**STAFF REPORT TO THE BOARD OF ARCHITECTURAL REVIEW
DEPARTMENT OF COMMUNITY DEVELOPMENT
Prepared September 28, 2018**

FILE NUMBERS: L08-079 Preliminary Subdivision
L18-0065 Design Review Major Modification

REQUEST: Request for approval of a Design Review Major Modification and a new Subdivision Preliminary Plat approval for the Osterly Park Townhomes subdivision. The original decision was issued in November 2009 and was updated in March 2012.

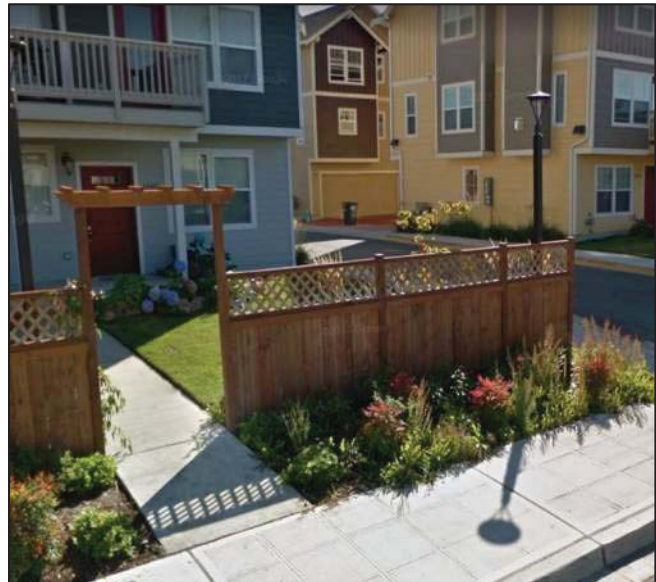
The graphic below shows the original pedestrian circulation, with red areas showing sidewalks and pedestrian crossings along the private access road linking to the project entries, recreation spaces, and on-street parking areas. Blue areas show linkages from the red/common walkway

areas to the private entries to Osterly Park Townhomes units. The proposed reconfiguration of Phase 2 includes sidewalks linked to recreation areas, on-street parking, and unit entries, except those units on the south side of the private access drive that will have garage and front doors on the same building elevation. Staff recommends a condition of approval to require the pavement area outside of the units having garage and front doors on the same building elevation be colored and patterned material similar the shared garage access areas, to symbolize shared use of the private road area for pedestrians and vehicles.

The addition of two on-street parking spaces east of the condo building and the grade difference between the Osterly Park Townhomes site and the condo site prevent the sidewalk from providing a continuous path along the west side of the private access road. Two pedestrian crossings of the private access road are proposed: (1) to connect the east and west sides of the sidewalk north of the on-street parking spaces adjacent to the condo building, and (2) to connect the sidewalk on the north side of the private access road to the recreation space located on the south side of the private access road. Pedestrian crossings of the private access road are proposed to be constructed of concrete and raised six inches to make these areas more visually prominent and to slow down vehicle traffic through the development.

1. The drive aisle from 34th Ave S to the recreation space Tract C shall be of colored and patterned material similar the shared garage access areas, to symbolize shared use of the private road area for pedestrians and vehicles.

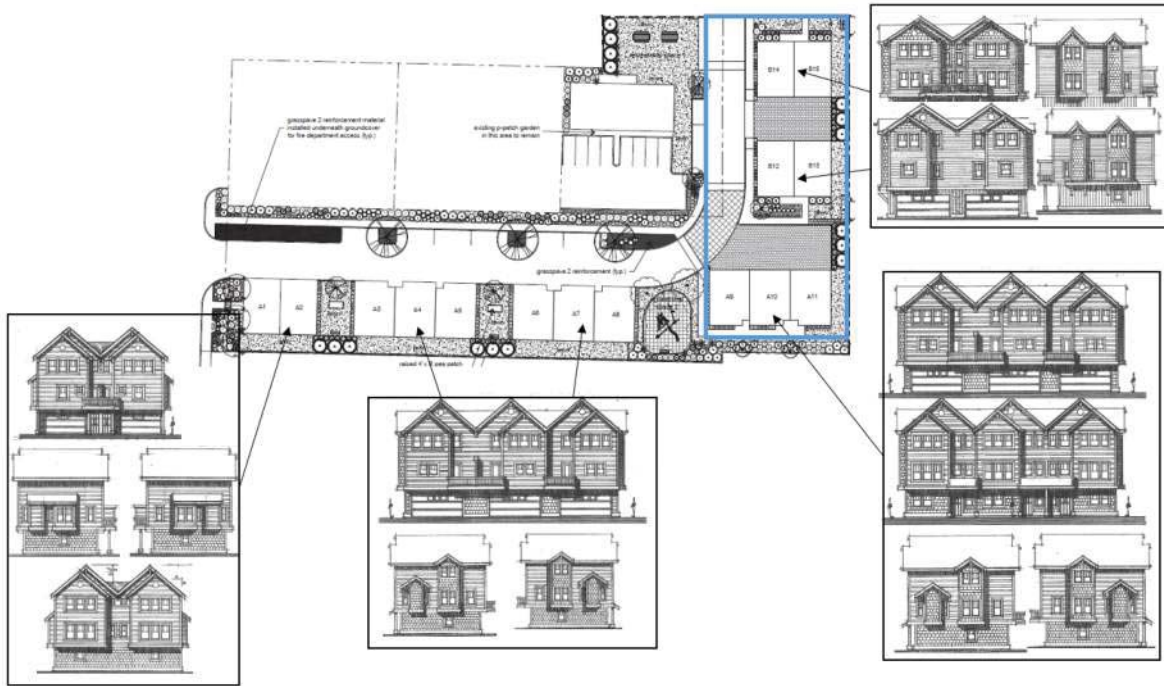
The building design outlined in blue remains as originally approved, including two, two-unit buildings, and one three-unit building. The other units on the south side of the private access road are where the townhome design and configuration are proposed to change most significantly from the original approval.

The original plan included two-unit townhome structures located on the north and south sides of the private access road. Townhome development west of the recreation space is now limited to the south side of the private access lane. To construct eight townhomes on the south side of the access road as originally approved, the townhomes have been reconfigured to include two three-unit townhome structures and one two-unit structure with frontage along 34th Ave S. These reconfigured units have both the garage doors and front doors on the same elevation facing the private access road. The architectural drawings shown above have not been revised to show (1) the front and rear elevations of the three-unit building, with garage doors and front doors on the north elevation and the design of the south elevation; and (2) the design of the two-unit building to show how the west elevation will have a front door and porch facing 34th Ave S. Staff recommends a condition of approval to require that these elevations be provided by the applicant and reviewed administratively as part of the building permits for these units.

5. Building elevations shall be submitted and reviewed administratively as part of building permits showing (1) the front and rear elevations of the three-unit buildings, with garage doors and front doors on the north elevation and the design of the south elevation; and (2) the design of the two-unit building to show how the west elevation will have a front door and porch facing 34th Ave S.

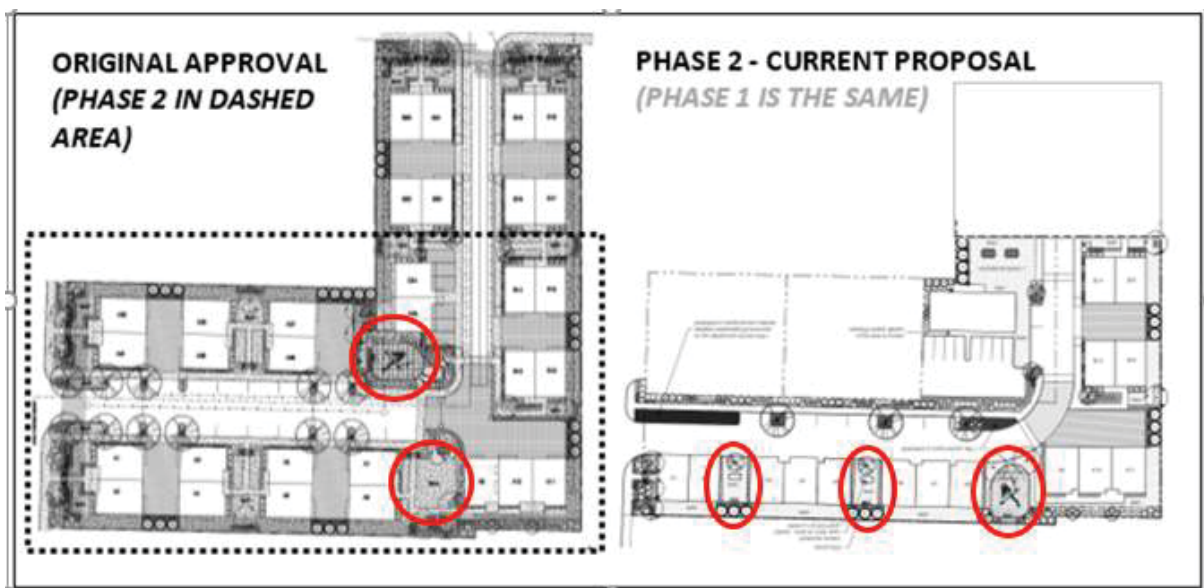
Staff recommends approval of the proposed landscape modifications. Some areas of the site provide more landscaping than required, which makes up the square footage where perimeter landscaping is not provided or where the width of the landscaping provided does not meet the full 10-foot width of landscaping required for side and rear yards. Areas that provide more landscaping than required include the frontage along 34th Ave S where a 20-foot-wide landscaping area is proposed instead of the 15-foot area required, as well as perimeter landscape areas in the southeastern corner of the site, near "recreation space 2". Additional landscaping is proposed in landscape islands between the on-street guest parking spaces. The total width of the landscaping area on the north side of the private access road is 10 feet. It includes only 6-8 feet of landscaping to incorporate a sidewalk separated from the access road. This is consistent with item d in criteria number 3 above.

Landscape clustering does not diminish the quality of the landscape as a whole: the appearance of the development is enhanced by grouping plantings at focal points at the ends of shared spaces such as garage access areas or recreation spaces, where they screen the perimeter fence and help to delineate shared spaces from private yard areas.

The new landscaping regulations, which apply to this project, require sites where more than 24 trees will be planted to have no more than 20 percent of trees planted on a site be of one species. Two of the tree species proposed, including the Green Arrow Alaska Cedar (*Chamaecyparis nootkatensis* 'Green Arrow') and the Serbian Spruce (*Picea omorika*), make up more than 20 percent of the total number of trees proposed. Staff recommends a condition of approval to require more diversity in the tree species.

4. Two of the tree species proposed, including the Green Arrow Alaska Cedar (*Chamaecyparis nootkatensis* 'Green Arrow') and the Serbian Spruce (*Picea omorika*), make up more than 20 percent of the total number of trees proposed. Landscape plan shall be revised to provide more diversity in the tree species.
